SUBJECT: Comments on NRC 820629 response to 820514 ltr re tornado  
 missile protection for diesel generator exhausts. Backfitting  
 would not justify cost. Requests item be deleted from SER  
 open item list.

Subject: WNP-2 TORNADO MISSILE PROTECTION  
FOR DIESEL GENERATOR EXHAUSTS

Fig. 1 - Topographical sketch of areas > 448'

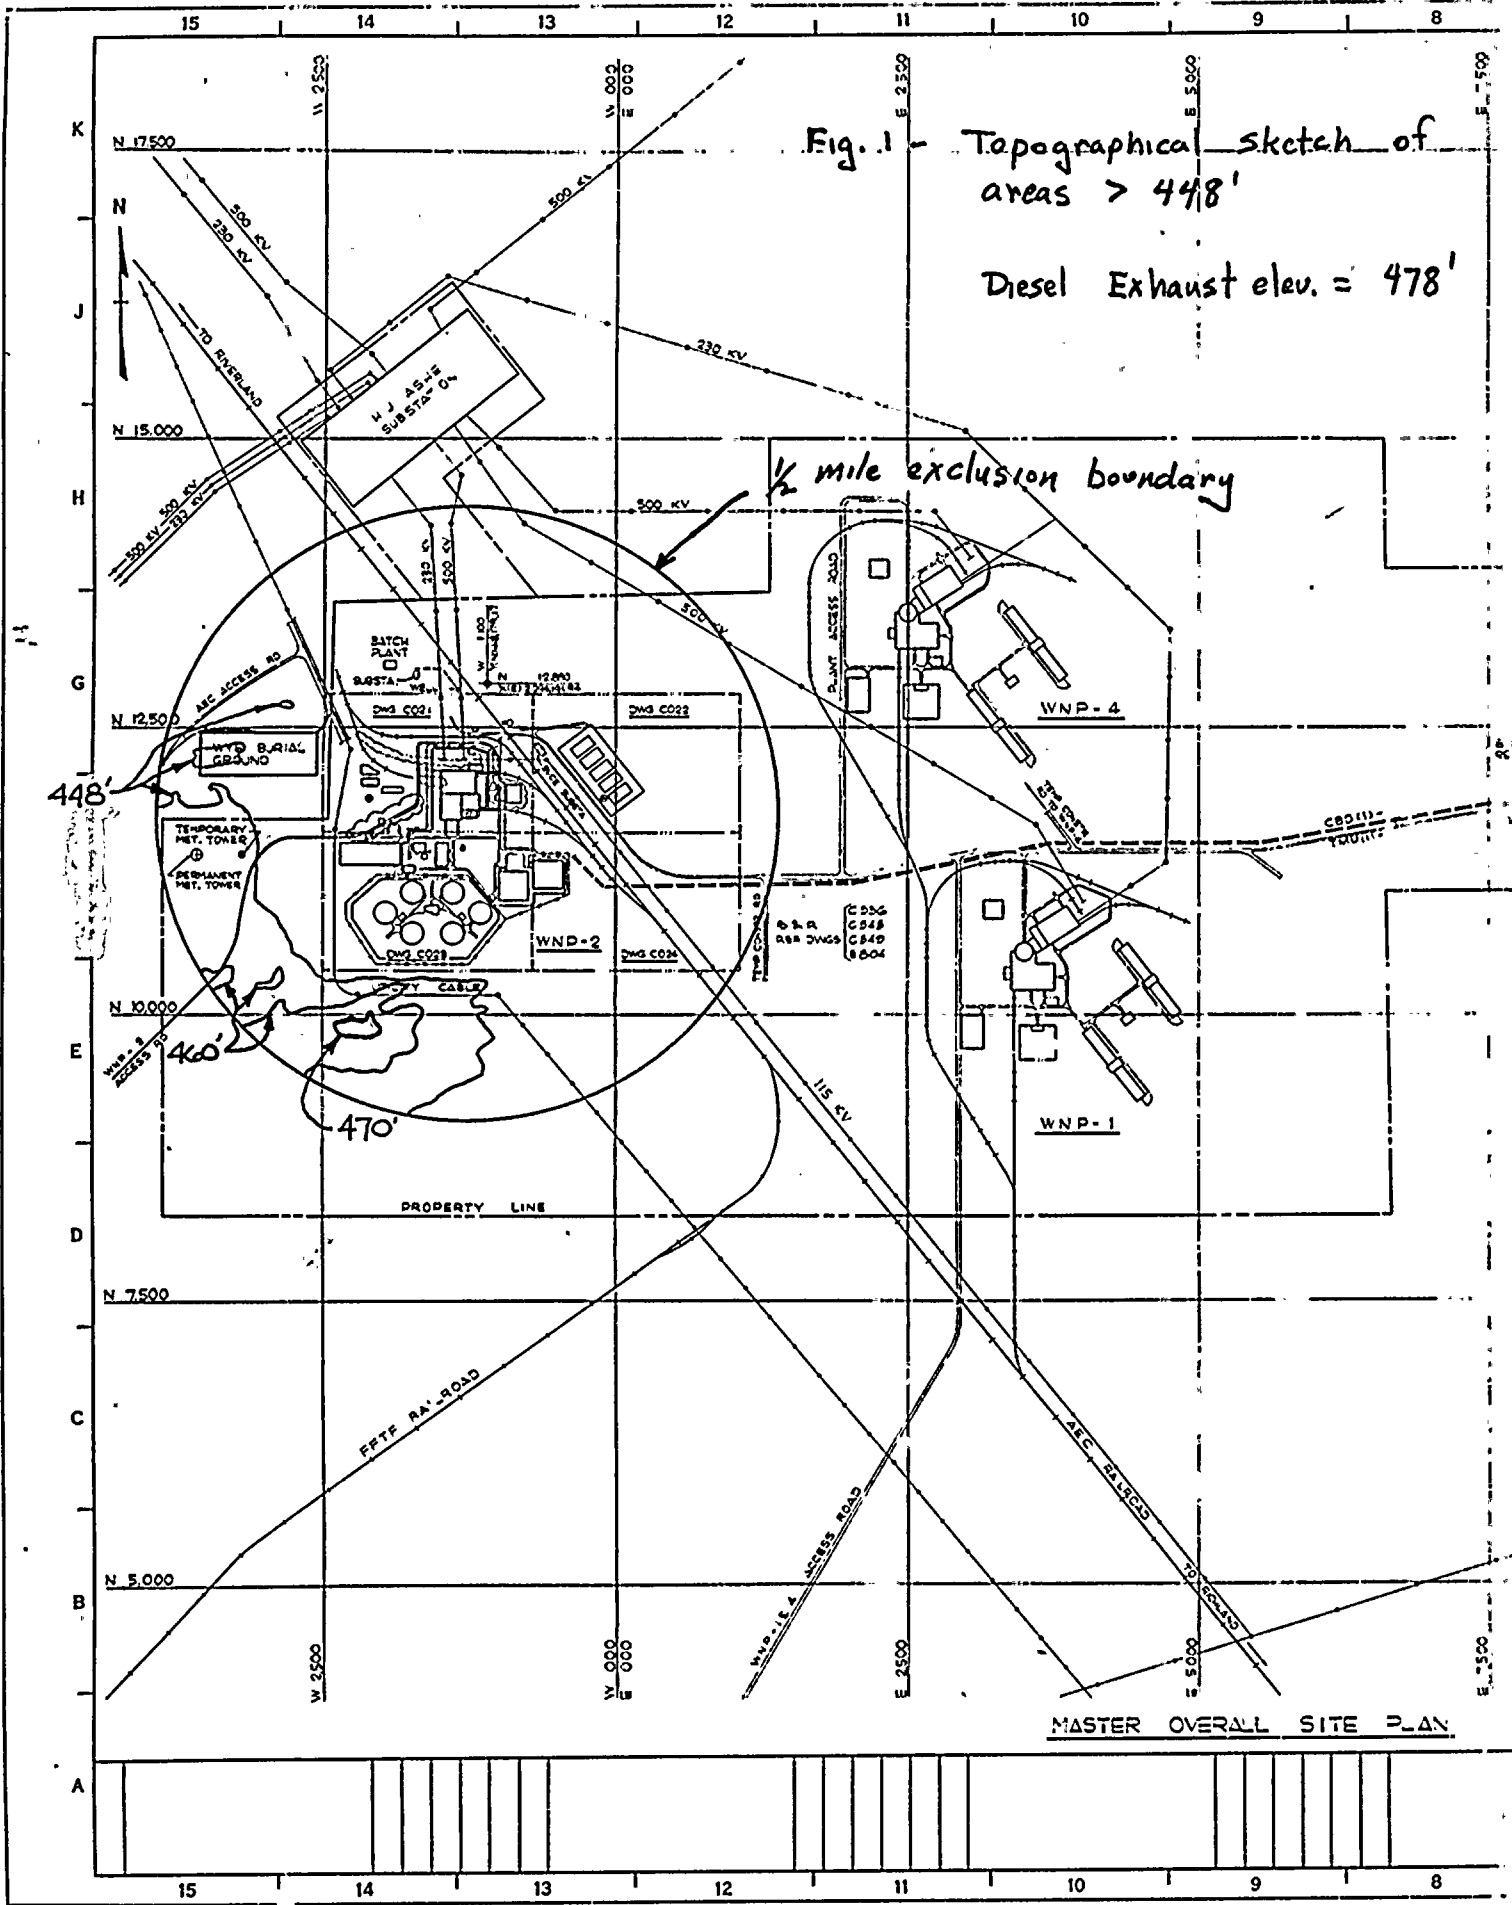
We believe it is important for the Staff to note the insignificance of the geographic features in question. It is hardly appropriate to term them a "bluff area" per Reference 2. As shown schematically in Figures 1 and 2, the highest point of elevation within one-half mile of the plant is below the elevation of the diesel exhaust. Further, the nearest point with a ground elevation higher than 448' (30 feet below the diesel exhausts) is more than 1,000 feet from the plant.
